# Technical Service Information

## FORD 4R70E/4R75E CHANGES FOR 2004

**CHANGE:** Beginning at the start of production for 2004, Ford Motor Company introduced a new rear drive transmission with the designation 4R70E or 4R75E, which is based on the 4R70W. This transmission now has a redesigned Pump and Stator assembly, Intermediate Clutch assembly, Forward Drum, Sun Gear Shell, Center Support, Anti-Rattle Clip, an added Turbine Speed Sensor, a redesigned transmission case, a shorter Output Speed Sensor and a redesigned Ring gear.

Figure 1

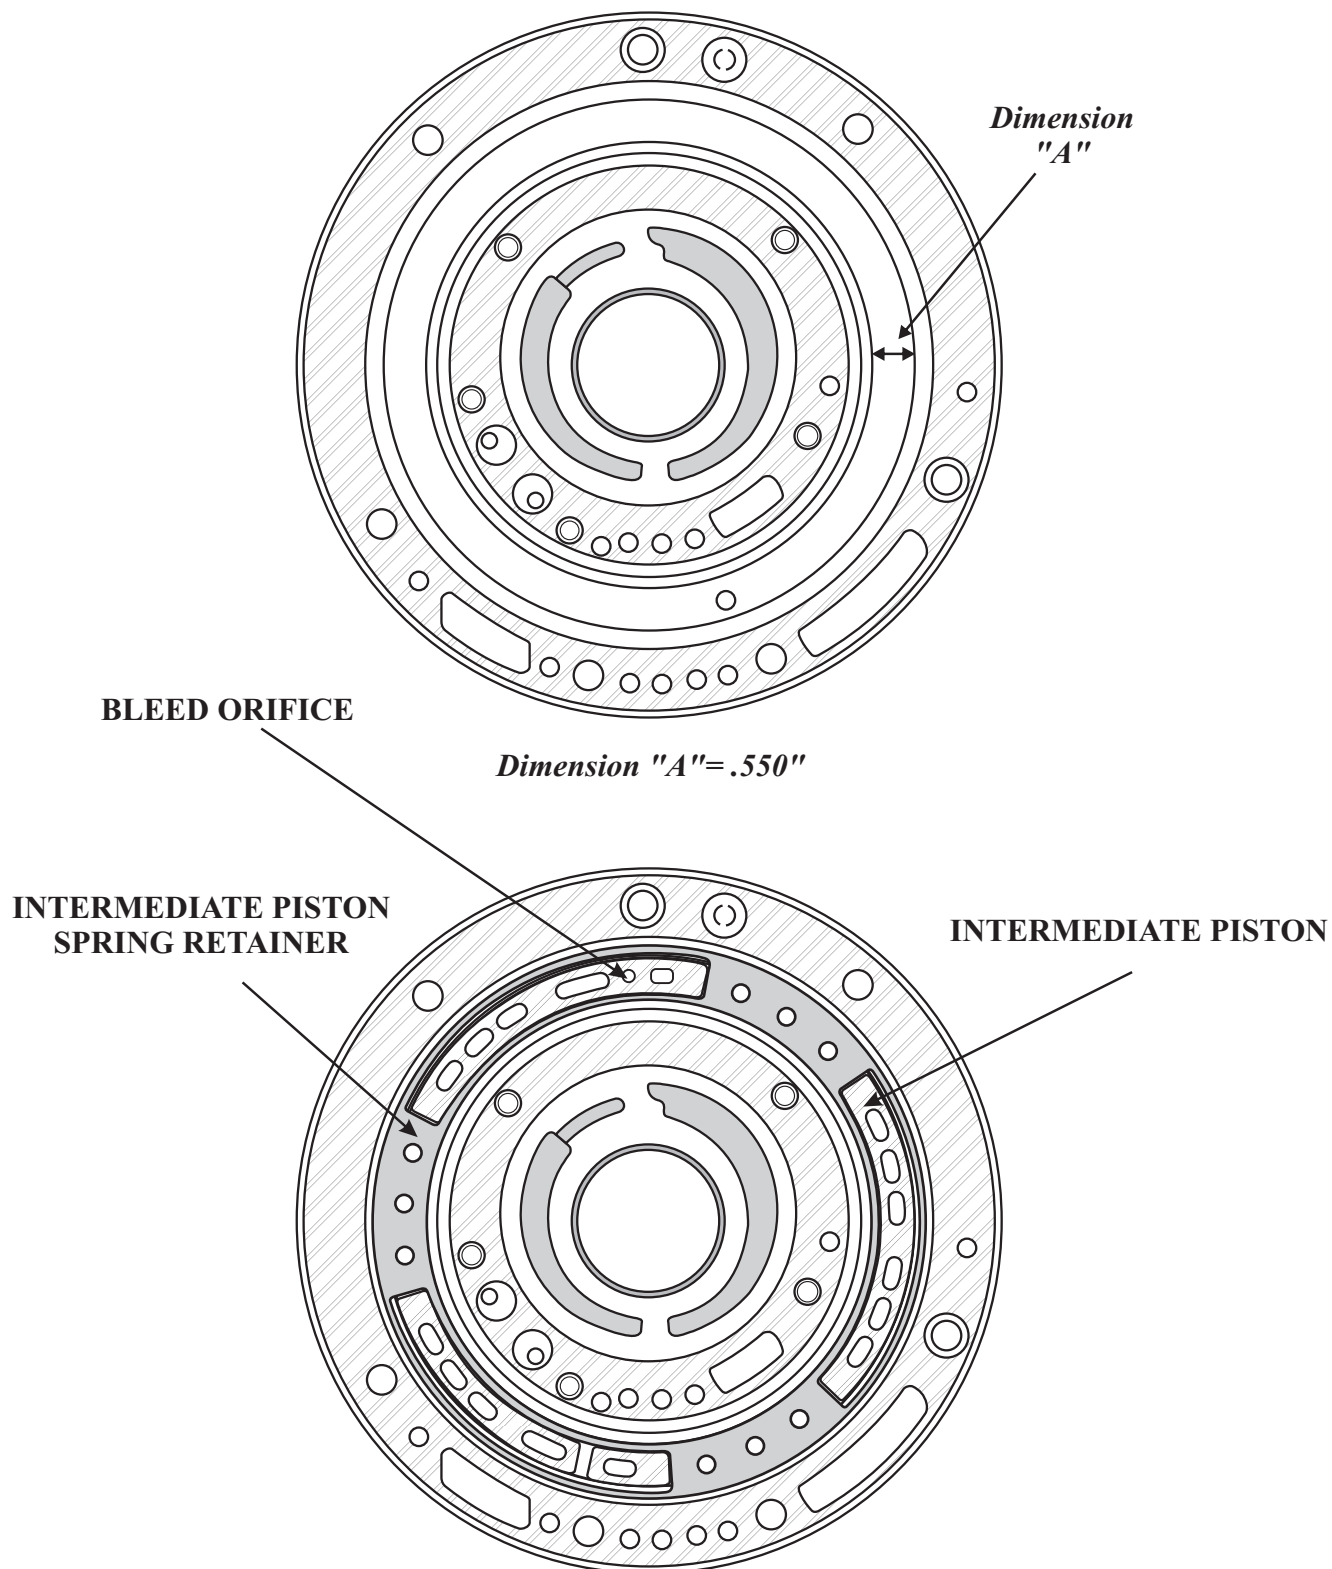
- (1) **INTERMEDIATE CLUTCH PISTON AND PUMP BODY** - The Intermediate Clutch Piston was changed from the previous design Aluminum piston with individual lip seals, as shown in Figure 1, to a stamped steel bonded rubber piston as shown in Figure 2. Along with this change, the Pump Body was redesigned to accommodate the new larger piston and the elimination of the Spring Retainer. A new return spring and retainer was added into the case as shown in Figures 3 and 4.

Figure 5

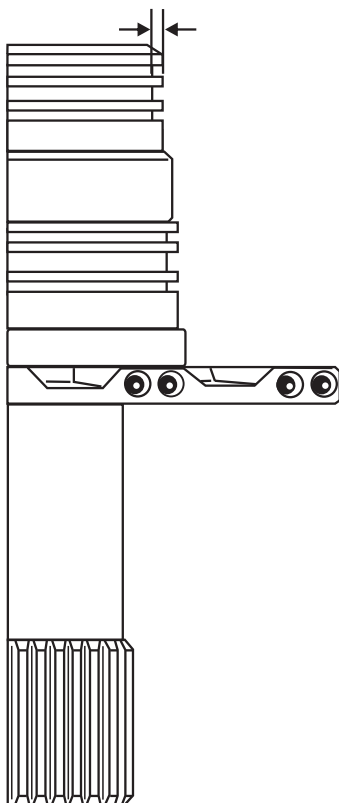
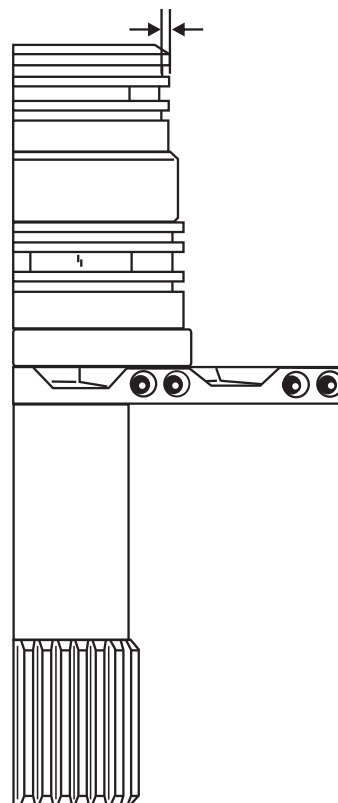
- (2) **PUMP STATOR** - The Pump Stator Forward Clutch sealing ring groove depth changed to accommodate a new Plastic Butt Cut Sealing Ring as shown in Figure 5.

**RING GROOVE  
DEPTH .100"**

**SEALING RING  
WIDTH .110"**

**LATCH TYPE STEEL  
SEALING RINGS**

**RING GROOVE  
DEPTH .072"**

**SEALING RING  
WIDTH .083"**

**BUTT CUT PLASTIC  
SEALING RINGS**

## FORWARD CLUTCH DRUM

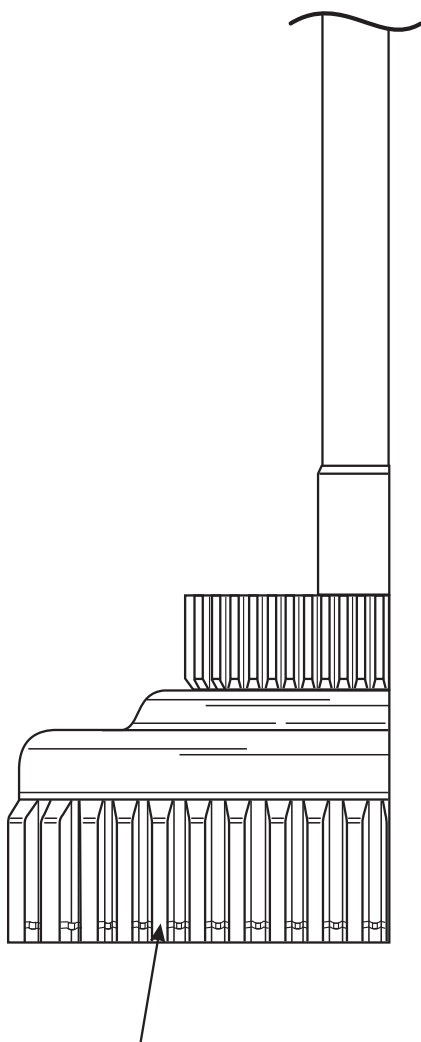
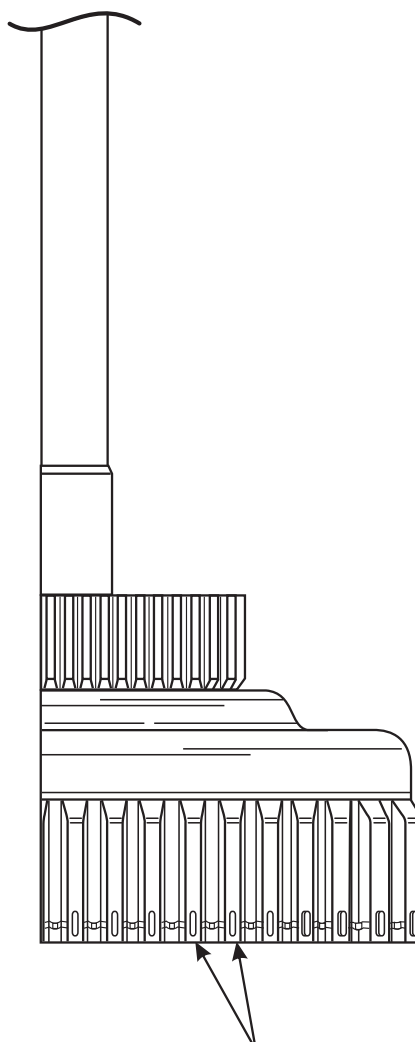
- (3) **FORWARD DRUM** - The Forward Drum had a stamping change to provide projections for the added Turbine Shaft Speed Sensor, as shown in Figure 6, and Forward feed was changed.

***NO PROJECTIONS AND 1 FEED HOLE  
IN THE DRUM FOR FORWARD CLUTCH***

***34 STAMPED PROJECTIONS  
ON THE OUTSIDE OF THE DRUM  
THAT THE ADDED TURBINE SENSOR  
READS FROM AND 3 FEED HOLES  
IN THE DRUM FOR FORWARD CLUTCH***

Figure 7

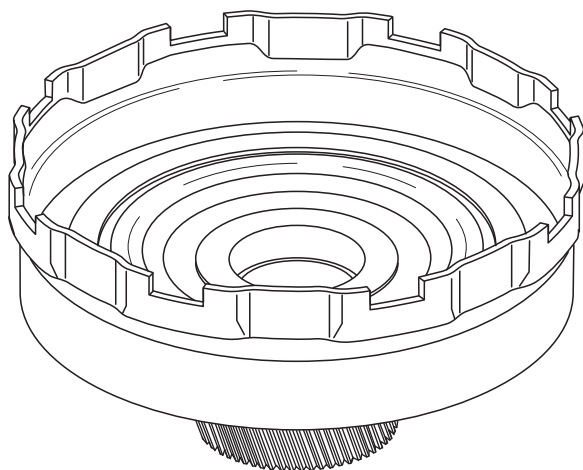
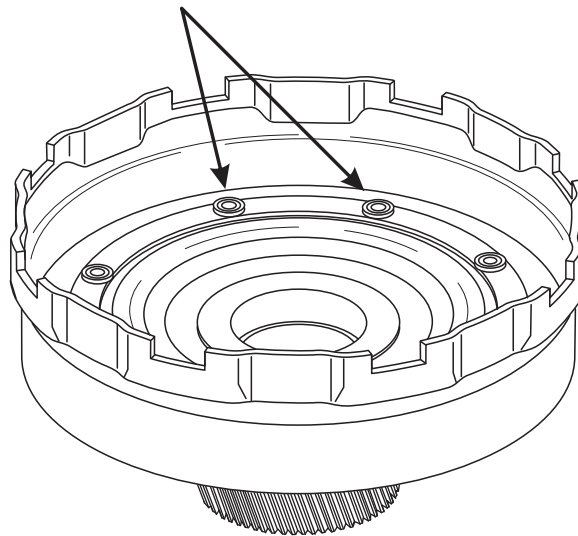
- (4) **SUN SHELL** - The Sun shell can be easily identified by the new rivets that retain the shell to the Sun Gear as shown in Figure 7. The new shell is manufactured from a non-ferrous metal which will not attract a magnet, so the added turbine sensor can read the Forward Clutch Drum. **NOTE: 2005 models do not have the rivets for identification and will retrofit to 2004 models.**

*New Sun Shell Is Now Riveted  
To The Sun Gear And Hub*

**NOTE:** *The New Sun Shell is made from  
a non-ferrous material so the Turbine sensor  
can read the Forward drum.  
In the 2005 model year the same type of Sun Shell  
is used and the rivets for identification are removed*

Figure 8

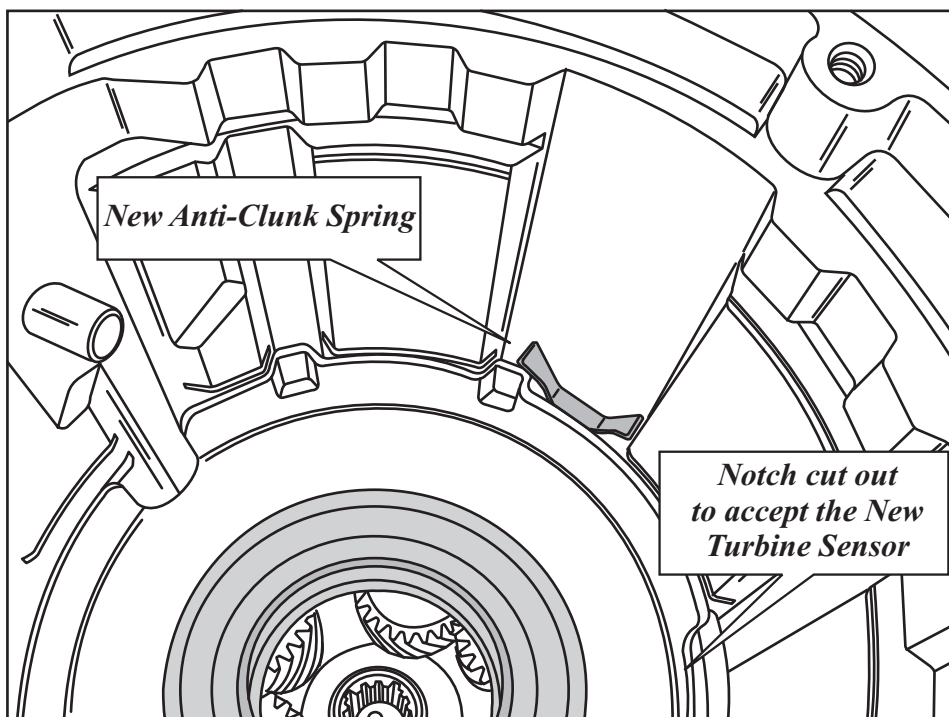
- (5) **CENTER SUPPORT** - The new design Center Support has a notch cut out of it to accommodate the added Turbine Sensor, as shown in Figure 8. A new design Anti-rattle Clip was also added for ease of assembly, which was changed in the 2002 model year.

### ***PREVIOUS DESIGN Anti-Clunk Spring***

### ***NEW DESIGN Anti-Clunk Spring***

***NOTE: The anti-clunk spring was  
changed in the 2002 model year.  
Ford part number 2L3Z-7F277-AA***

Figure 9

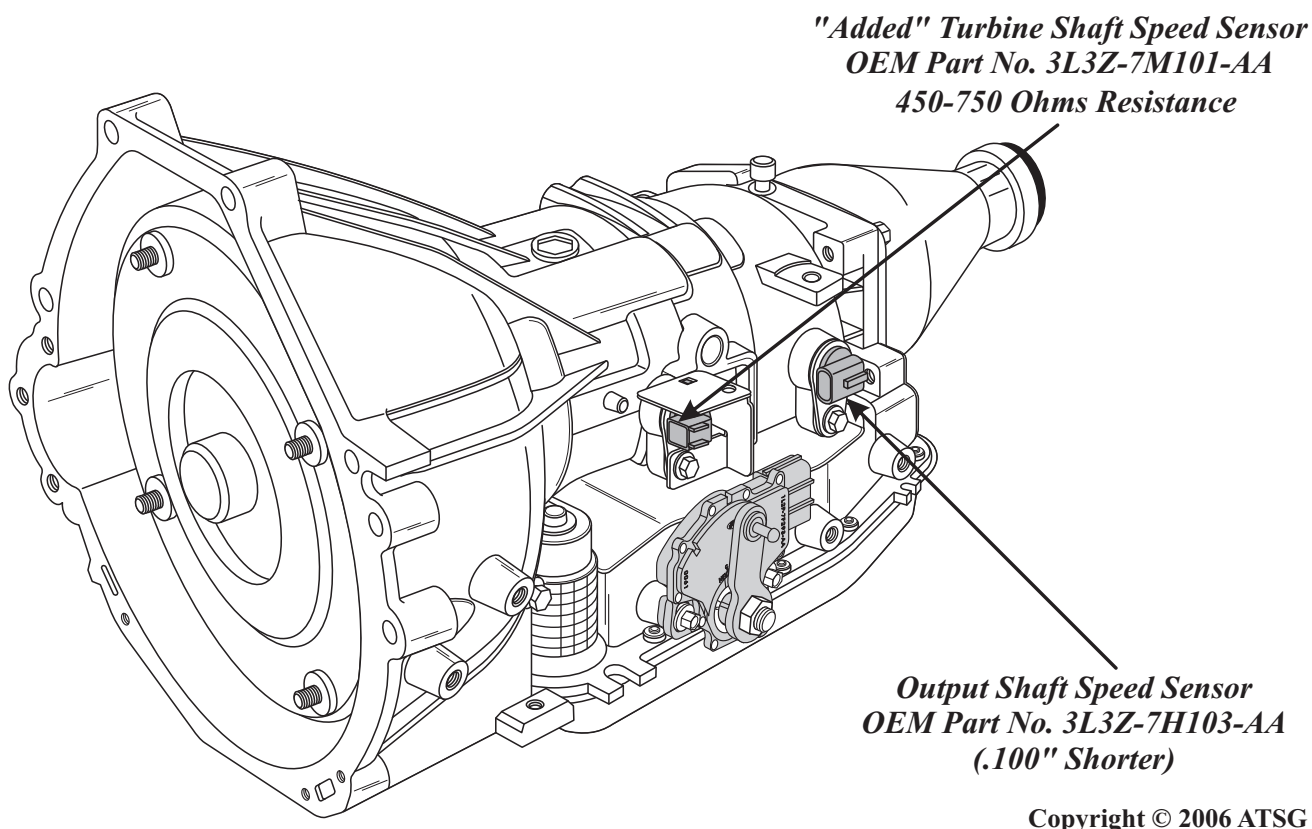
- (6) **TRANSMISSION MAIN CASE** - The case was changed to accommodate the added turbine sensor as shown in Figure 9.
- (7) **REAR INTERNAL RING GEAR** - Now manufactured with extended parking lugs on the ring gear to trigger the New **Shorter** Output Speed Sensor, instead of the previous design holes in the center of the ring gear as shown in Figure 10.

Figure 10

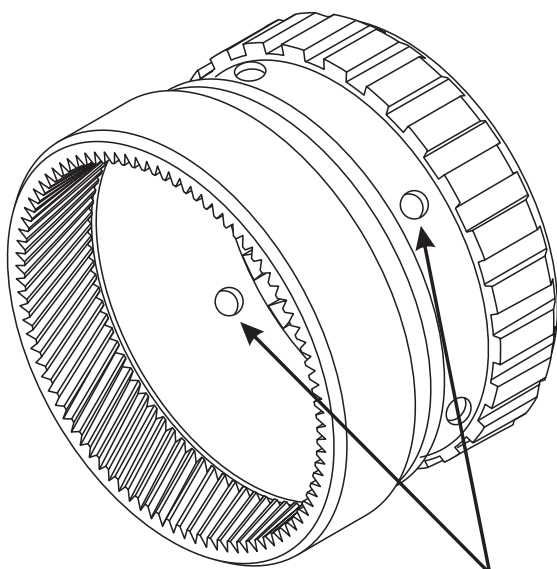
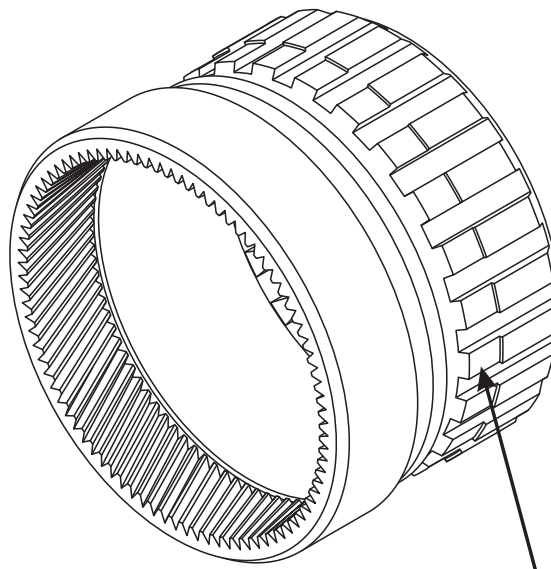
*Holes To Trigger  
Speed Sensor*

*Extended Teeth To Trigger  
Speed Sensor*
